Title: Cavalon Oil Thermostat Assembly Upgrade		Compliance Category: A – MANDATORY B – RECOMMENDED C – OPTIONAL
AG-SB-2020-02-B-EN		
Applicability		
Aircraft type & model: AutoGyro Cavalon	Affected Serial number(s): All Cavalon fitted with the Rotax 915iS engine up to V00473 but excluding V00398, V00443 & V00450	
The maintenance manual to be referenced is this stated or subsequent issue.		As per AutoGyro website
<p>This form is the response from AutoGyro GmbH either against a problem found in the product in service requiring a containment or rectification action, or as service information for aircraft modification incorporation. For help, contact AutoGyro on +49(0)5121 88056-00, or email airworthiness@auto-gyro.com.</p>

Reason and overview of the Service Bulletin (cause of problem if known)

(Pic. 1)

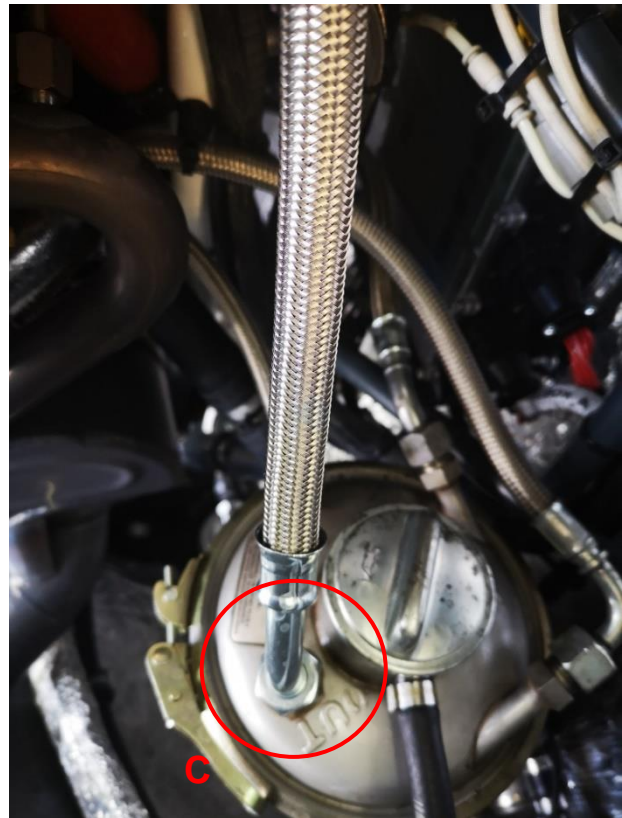
4. Confirm the size of the adaptor at the oil pump (Pic. 1 item A). If the thread size is anything other than 22mm then it must be replaced with adapter **45583**. If the thread is 22mm then no further action is required.

6. Return the oil in the system to the tank by turning the propeller until a gurgling sound is heard.
7. Place a container under the oil pump at the rear of the engine, and disconnect the oil hose (Pic. 1, item A). Allow any oil to drain and remove the P-clamp (Pic. 1, item B).

(Pic. 3)

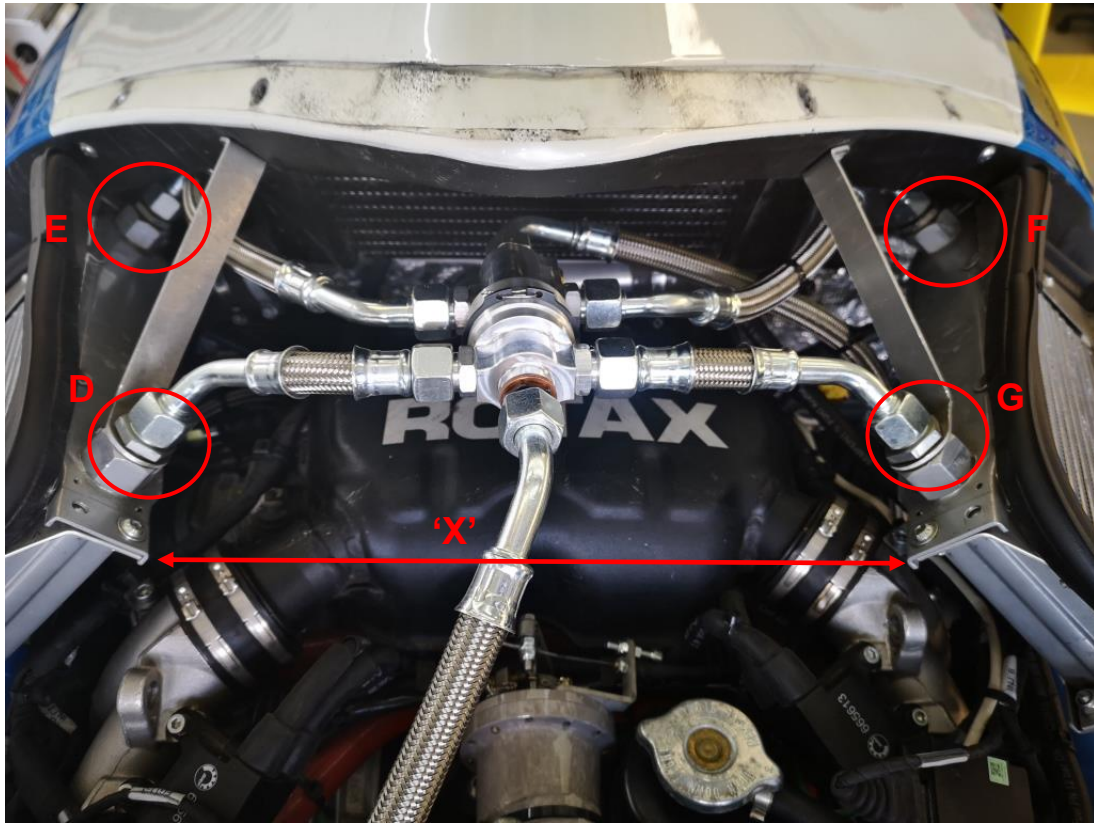
1. Ensure the wheel brakes are applied and the mag switches/ignition are switched in the "off" position.
2. Remove the upper and lower engine cowlings.
3. Measure the distance between the oil cooler corners as shown in Pic. 3 dimension 'X' to determine which hose set is required. If dimension 'X' is 280mm then oil hose set **47896** is required, if dimension 'X' is 335mm then oil hose set **47817** is required.

8. Disconnect the return hose from the right side oil cooler at the oil tank connection (Pic 2, item C)
9. Place a container under the oil cooler hose connections and disconnect the 4 hoses from the oil coolers (Pic 3. Items D, E, F & G). NOTE: Ensure to counter the adapters when dis-assembling and assembling the hoses on the coolers.
Note: The thermostat and hoses are now supplied as separate items.

(Pic. 4)

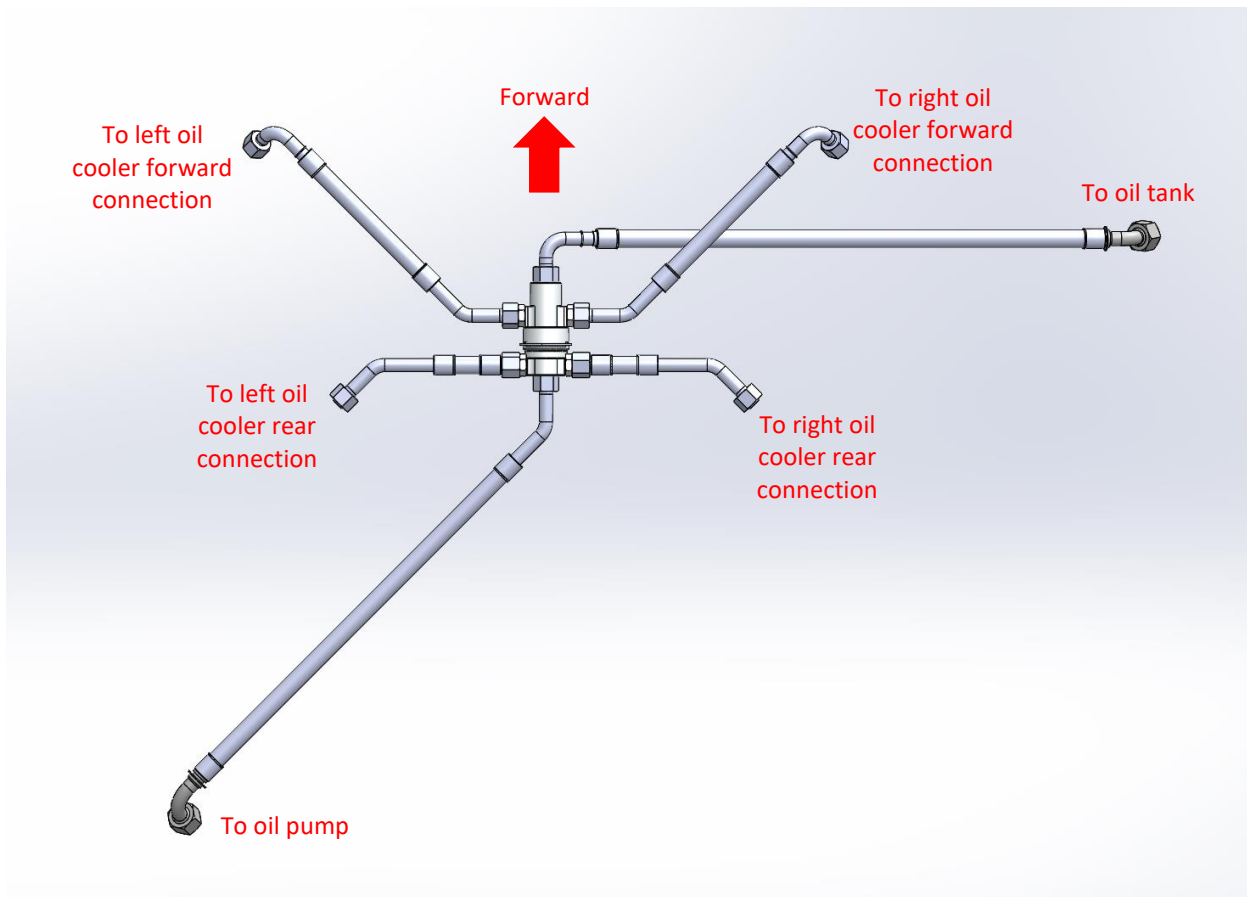
10. Assemble the new hoses (47896 or 47817) to the new thermostat (47748) loosely. Ensure that the items are assembled in the correct orientation as shown in Pic. 4.
